Final Drainage Report

WHMD RWRF STORMWATER IMPROVEMENTS El Paso County, Colorado

PCD Filing No.: CDR268

V2_Drainage Letter.pdf Markup Summary

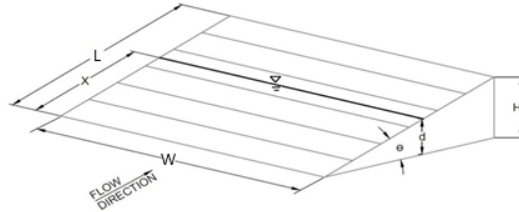
WARNING: MINOR STORM max. allowable capacity is less than the design flow given on sheet 'Inlet Management'
WARNING: MAJOR STORM max. allowable capacity is less than the design flow given on sheet 'Inlet Management'

Both the 5 and 100 year flows are exceeding the capacity of the swale. Please revise swale design to have sufficient capacity. If there is a reason/constraint that the swale is undersized, please include discussion in the narrative and that there will be no adverse impact to the site or downstream.
